**International Aero Engines  
NON-MODIFICATION  
SERVICE BULLETIN**

**ENGINE – HP COMPRESSOR, STAGE 6 ROTOR PATH - DUAL METCO 313 ENGINED AIRCRAFT  
- FLEET MANAGEMENT ACTIONS – NON-MODIFICATION SERVICE BULLETIN**

This document transmits Revision 2 of Non-Modification Service Bulletin V2500-ENG-72-0445

**V2500-ENG-72-0445**

Fig 2 – Missing topcoat not exposing basecoat

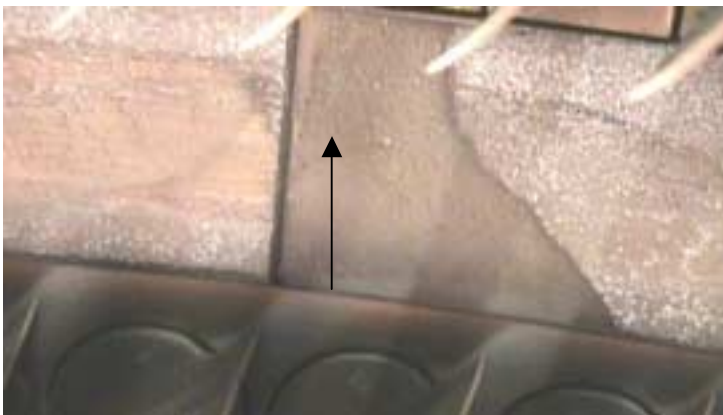
- A. Lining material sound and grey in colour or with light surface deposits, white in colour (Refer to Fig 1) – Acceptable.
- B. Missing topcoat not exposing basecoat. Remaining topcoat sound, without blistering or flaking (Refer to Fig 2) – Acceptable.

Figs 5 & 5a – Examples of corrosion related pitting, lifting, flaking or blistering of topcoat surface

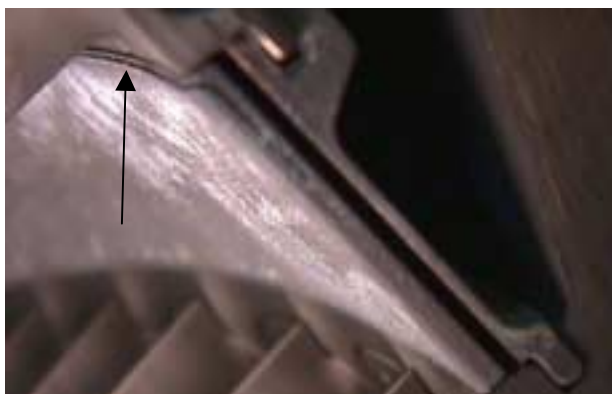
- D. Surface craze cracks with no missing material or lifting (Refer to Fig 4) - Accept. Large, open cracks – Unacceptable.
- E. Surface corrosion resulting in topcoat, lifting, blistering, bulging or swelling (Refer to Fig 5) – Unacceptable.

Fig 6– Delamination of topcoat/bondcoat interface

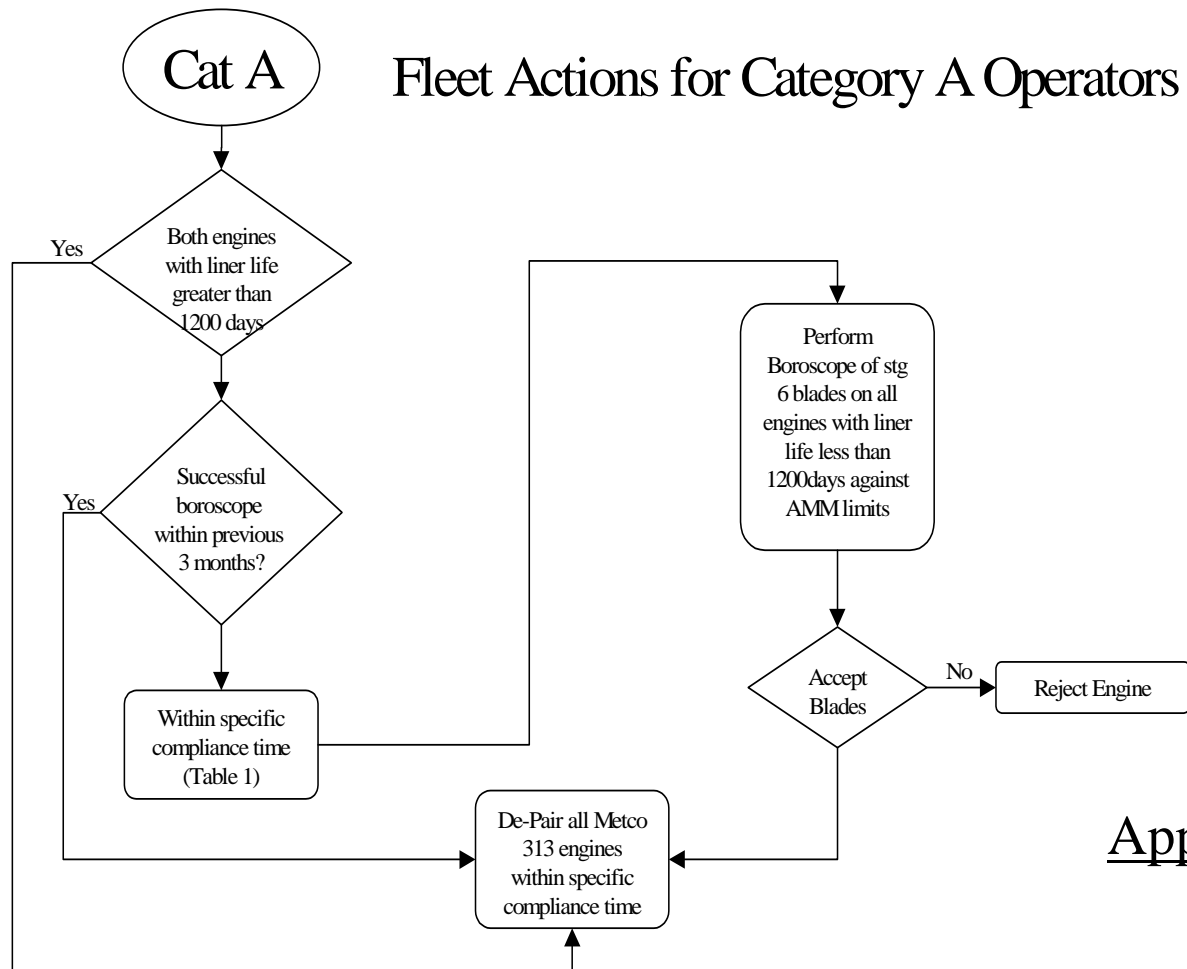
- F. Lifting/delamination. If there is evidence of delamination between the topcoat and bondcoat interface (Refer to Fig 6) – up to 1" (25 mm) circumferentially – Acceptable. More than 1" (25 mm) circumferentially – Unacceptable.
